South Coast Air Quality Management District
21865 Copley Drive, Diamond Bar, CA 91765-4182
(909) 396-2000 • www.aqmd.gov

April 4, 2013

Re: Appeal from March 7, 2013 decision of the Port of Los Angeles-Board of Harbor Commissioners to approve the Final Environmental Impact Report for the Southern California International Gateway Project and associated approvals (ADP No. 041027-199/SCH No. 2005091116)

Figure 1: Surrounding Residential and Sensitive Land Uses Near Proposed SCIG Facility

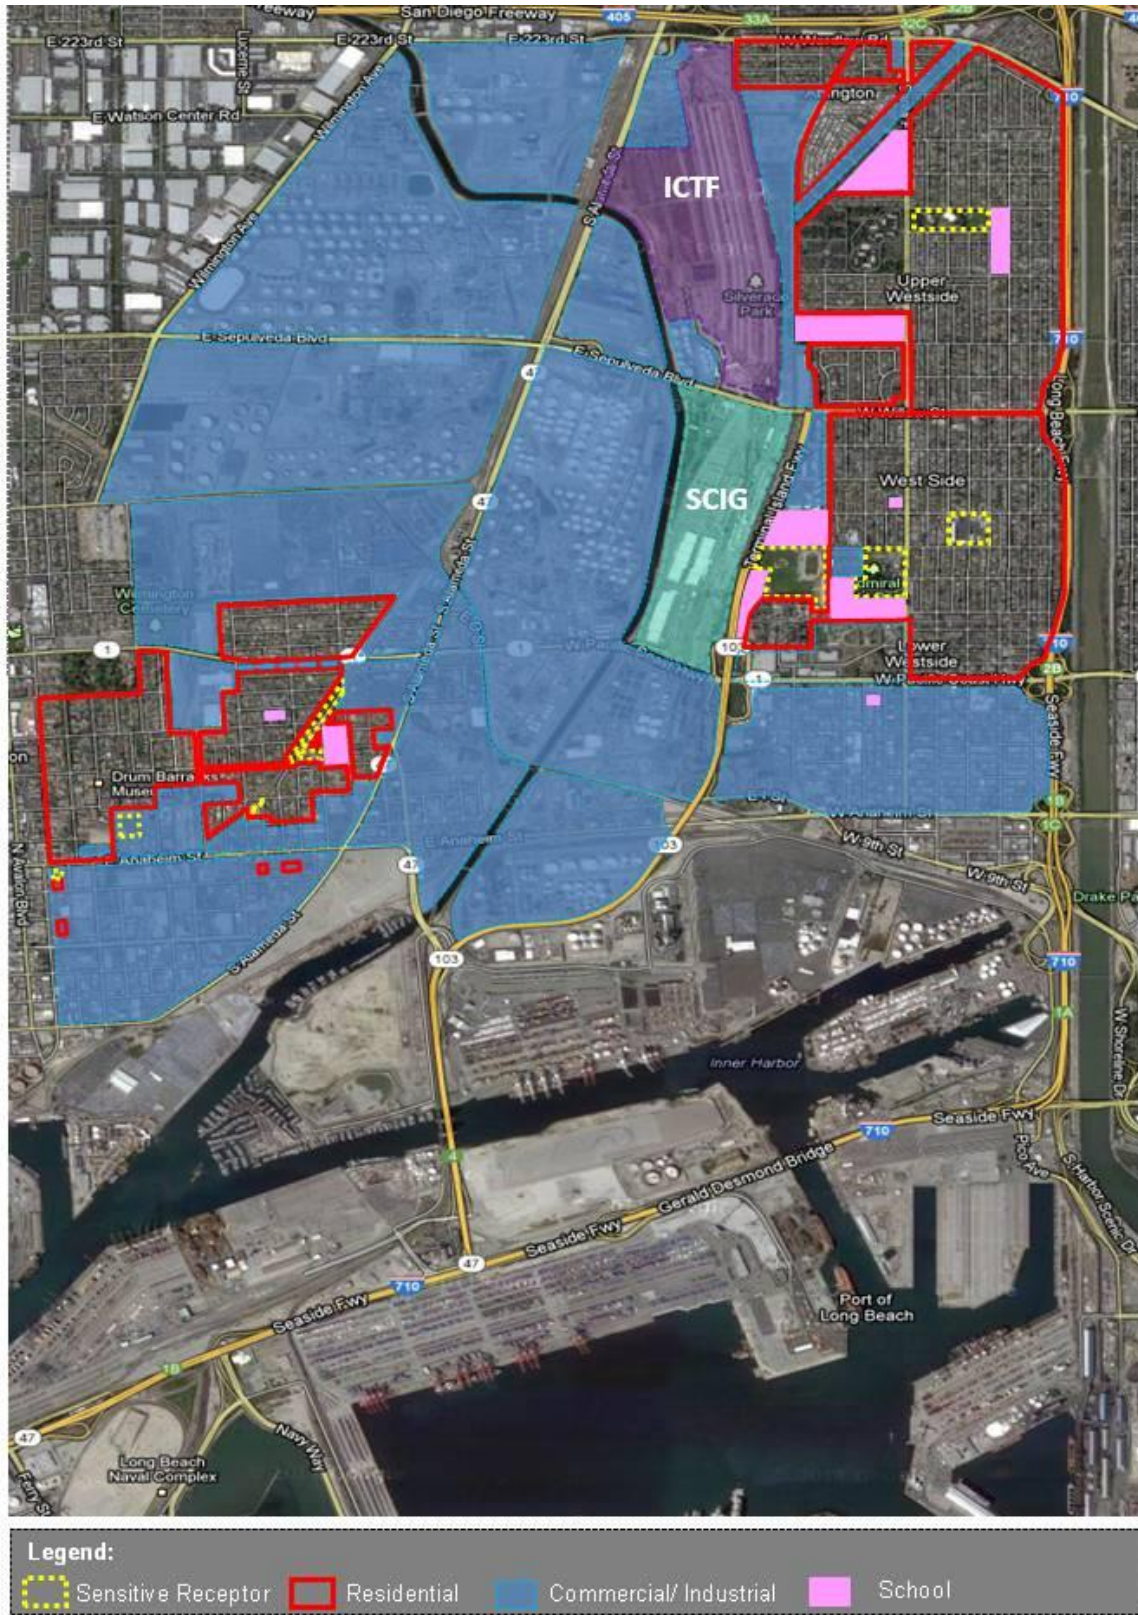
The South Coast Air Quality Management District (SCAQMD) staff appreciates the opportunity to comment on the Draft Environmental Impact Report (DEIR) for the Southern California International Gateway (SCIG) Project. Our comments seek an EIR that fully evaluates and discloses environmental impacts of the project, and that identifies for the proposed project's decision makers all feasible measures to mitigate significant impacts. Air quality impacts of the Proposed SCIG project must be carefully evaluated and mitigated because the railyard will be one of the largest intermodal facilities in the nation, and will be located near residences, schools, a pre-school, and a veterans center. The West Side neighborhood of Long Beach is home to approximately 13,500 residents¹ and lies between the project site and the I-710 freeway, but as close as 1,000 feet from the proposed project. In addition, Hudson School, an elementary and middle school with over 1,000 students, is less than 600 feet from the eastern boundary of the proposed Project site². The Mary Bethune School and Cabrillo Child Development Center are less than 500 feet from the eastern boundary of the proposed site. See Figure 1.

Figure 2: 1-Hour NO₂ Unmitigated Impacts

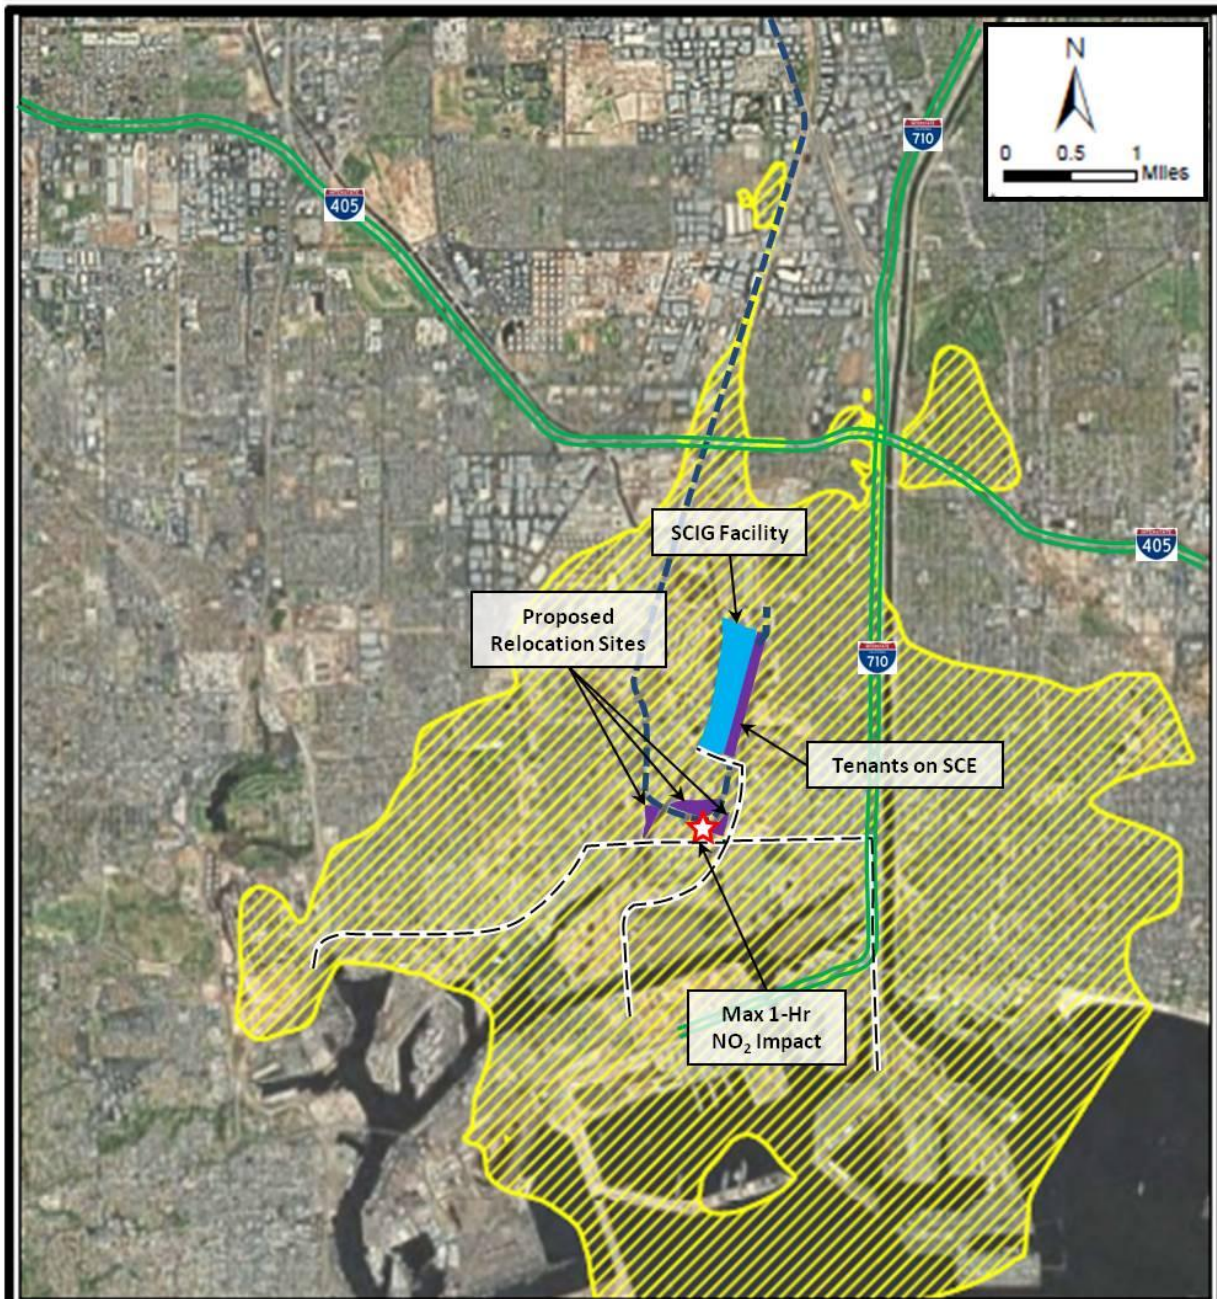
The Proposed SCIG Project will result in significant localized impacts of NO₂ and PM₁₀. As depicted in Figure 2 below, NO₂ is expected to exceed federal standards over a wide area, including population centers in west Long Beach and Wilmington. Concentrations of NO₂ in the community from the project alone are predicted to exceed the federal standard by at least a factor of five (Table 1 below). The modeled point of maximum NO₂ impact is located adjacent to the relocated tenants south of the project site. PM₁₀ impacts are predicted to exceed the annual and 24-hour SCAQMD Air Quality Significance Threshold by a factor of about 20. The area of PM₁₀ impact also extends into the west Long Beach community adjacent to the SCIG facility (Figure 3 below).

Figure 1
Simplified Air Quality Dispersion Modeling Process Flowchart

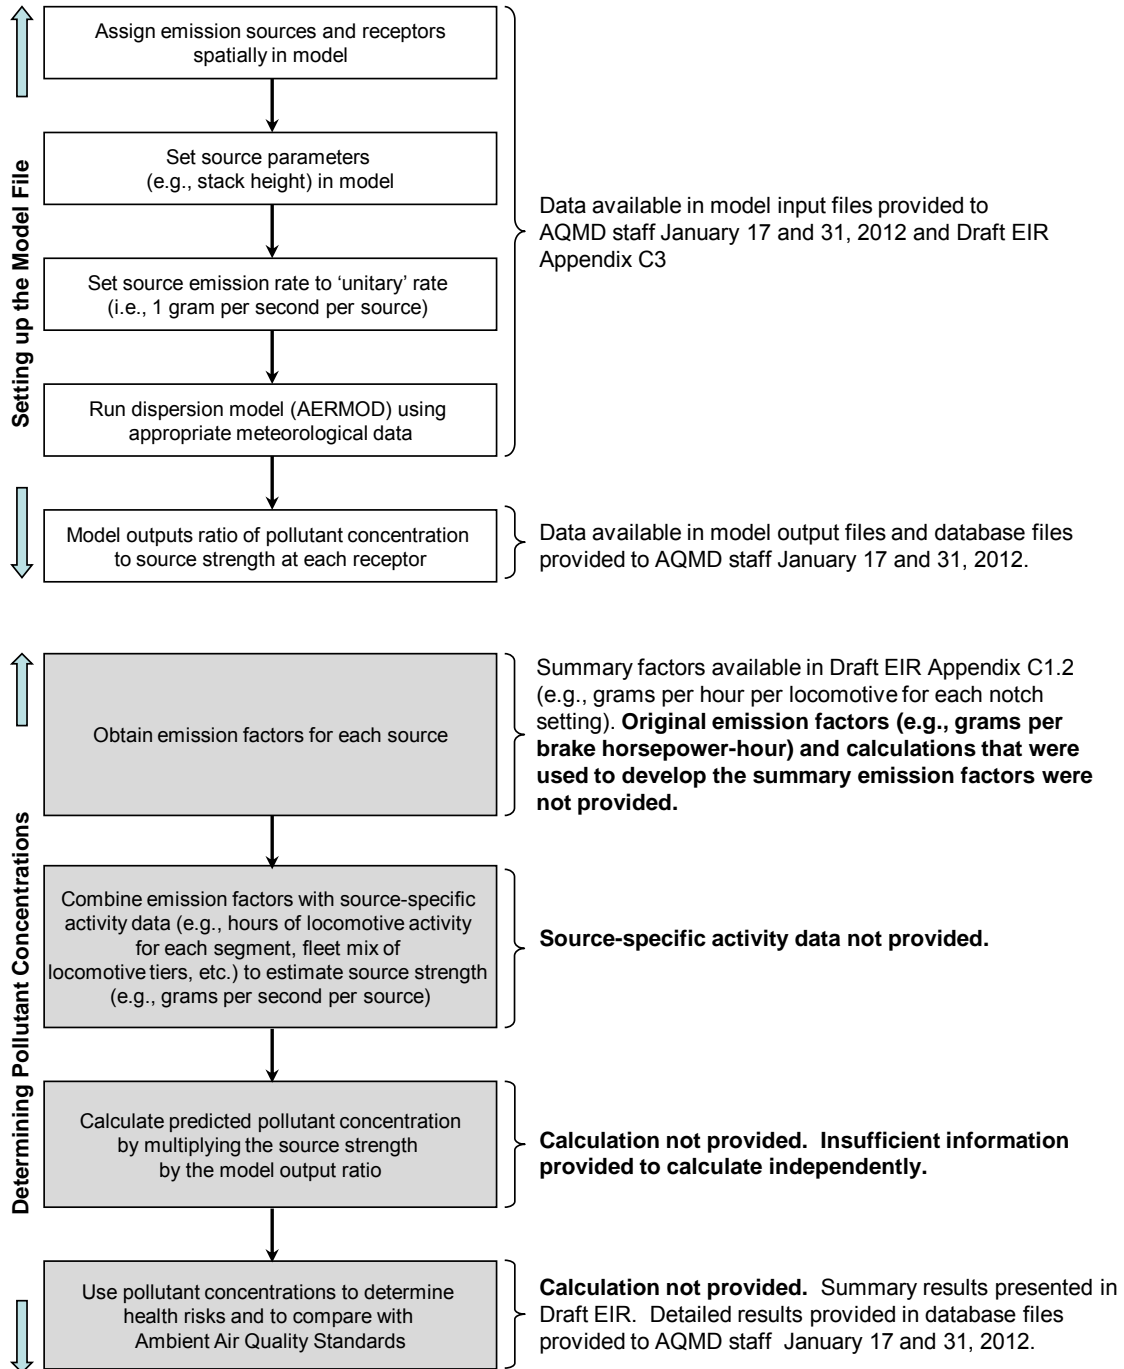
Figure 1 below presents a simplified flow chart describing the steps that are followed to convert emission factors into predicted pollutant concentrations using a dispersion model like AERMOD. As can be seen in the figure, critical data was not provided to AQMD staff or to the public. This data is necessary to confirm the validity of the results of the dispersion modeling analysis. A

Note: Shading indicates information not provided that is critical to calculating pollutant concentrations

Figure 2
Figure C3.4-2 from DEIR
(Legend Shows Only Switcher Locomotive Idling)

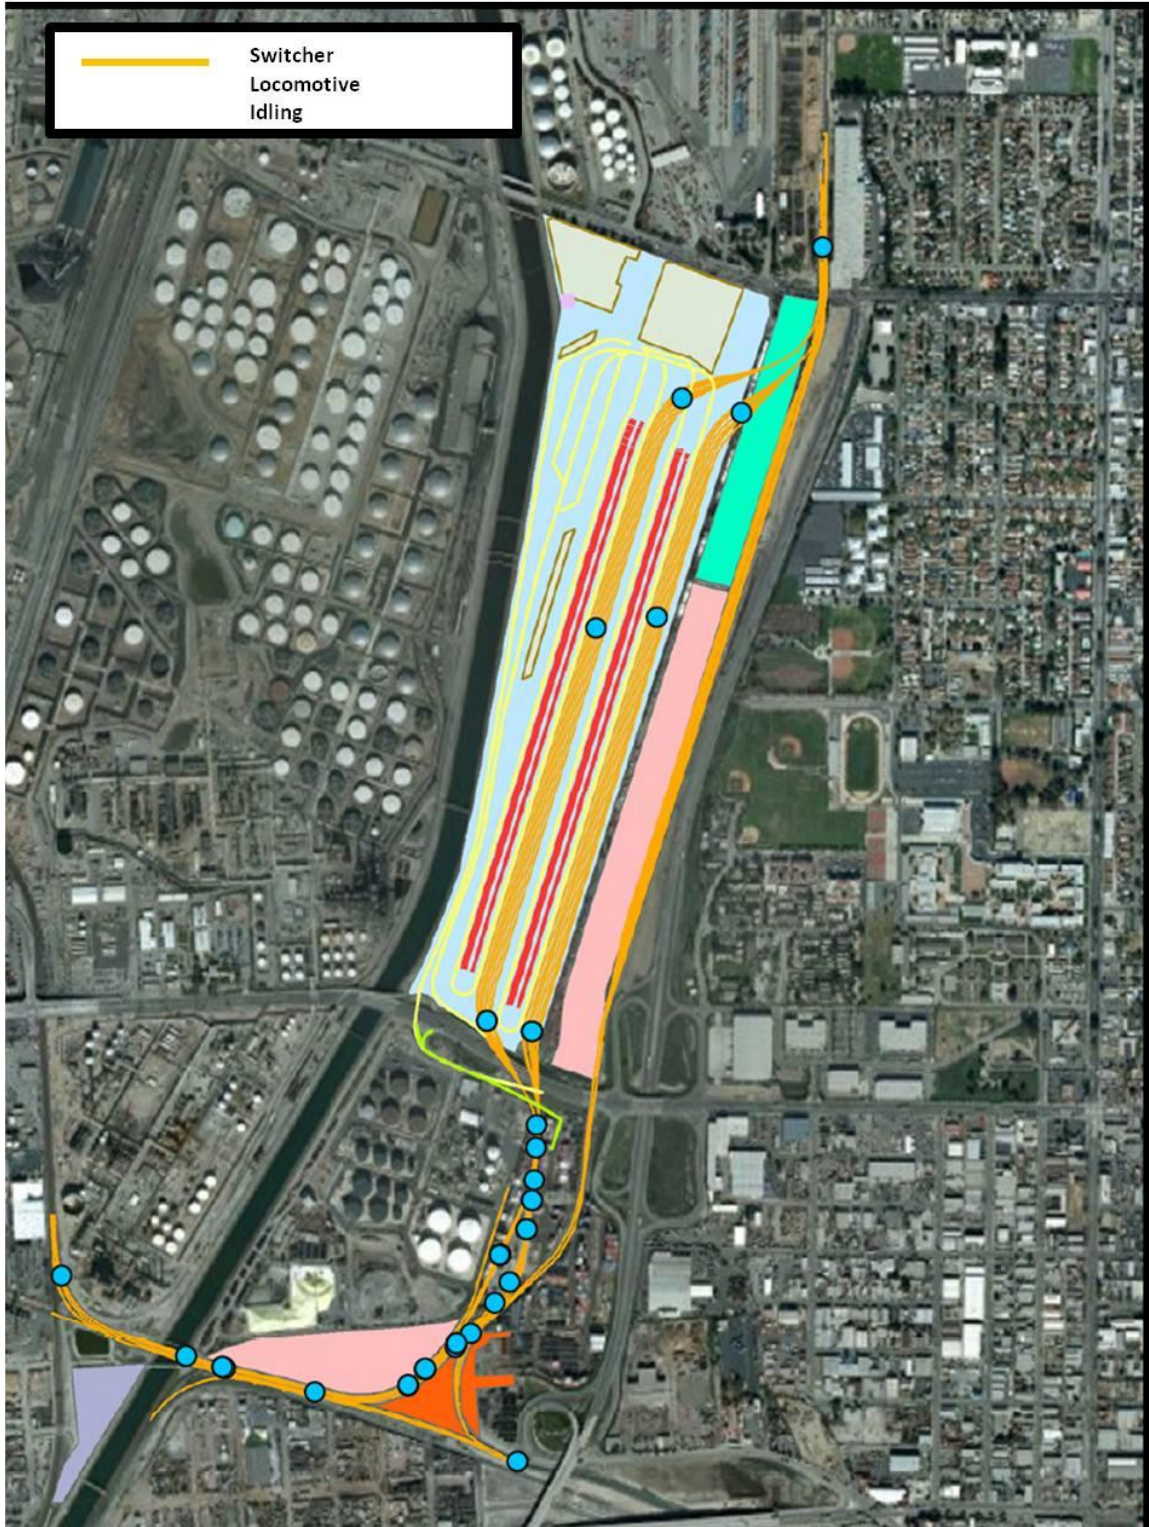
Although emissions calculations used to conduct to air dispersion modeling could not be completely reviewed, the location of emission sources was available. There appears to be a disconnect between the text of the DEIR and the location of locomotives that were modeled for the proposed project. The DEIR shows (Figure 2) locomotive emissions along the San Pedro Branch Line would occur south of Stephens Middle School. In the modeling files (Figure 3) the locomotive emissions along the San Pedro Branch Line extend well north of Stephens Middle School near the residential community of West Long Beach. If the proposed project will result in locomotives operating on the northern portion of the San Pedro Branch Line, that should be appropriately reflected in the DEIR, such as in Figure 3.

Locomotive Peak Daily Emissions

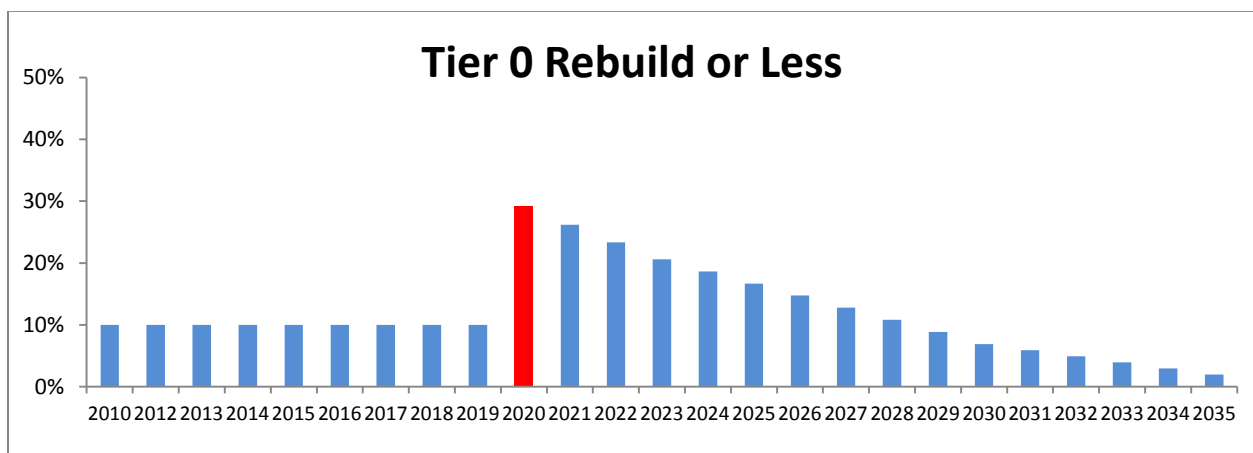
The Recirculated DEIR contains insufficient information for the public to determine the reasonableness of the locomotive peaking factor used to calculate peak day locomotive emissions. In the Draft EIR, peak day locomotive emissions were estimated assuming that all daily locomotive trips on the peak day were conducted by the lowest Tier level locomotive in the fleet mix for each analysis year. The AQMD staff did not comment on this approach because it was conservative, in that it produced locomotive emissions based on the highest emission rate available in the projected fleet. However in the Recirculated DEIR, peak day locomotion emissions were determined by applying a peaking factor to all future year locomotive emission factors. The peaking factor used in the Recirculated DEIR has substantial impacts on the locomotive emissions reported for the proposed Project. For instance, the 2035 NO_x emissions for the proposed Project in the Recirculated DEIR and Draft EIR were 916 pounds per peak day and 3669 pounds per peak day, respectively. This amounts to a 75 percent drop in off-site NO_x locomotive emissions in 2035. The peaking factor used in the Recirculated DEIR was derived by assuming a ratio of the peak day locomotive fleet mix average emissions factor in 2010, to the average day locomotive fleet mix average emissions factor in 2010. No supporting data or information is provided in the Recirculated DEIR on the underlying assumptions that went into deriving the peaking factor. As a result, the AQMD staff is unable to verify that the peaking factor is reasonable.

The application of the peaking factor to future locomotive emission rates further exacerbates the belief of AQMD staff that future locomotive fleet mixes, assumed in the emission rates tables of Appendix C1.2-21 and C1.2-22, over-predict the penetration of Tier 4 locomotives in milestone years 2023 and 2035. When coupled with the peaking factor, it results in an underestimation of the emission rates (and therefore emissions) for the peak day scenario. The approach used in the Draft EIR avoided this problem somewhat by assuming that the peak day emission rates were based on the lowest tier (highest emission rate) locomotive making up the fleet in a specific year.
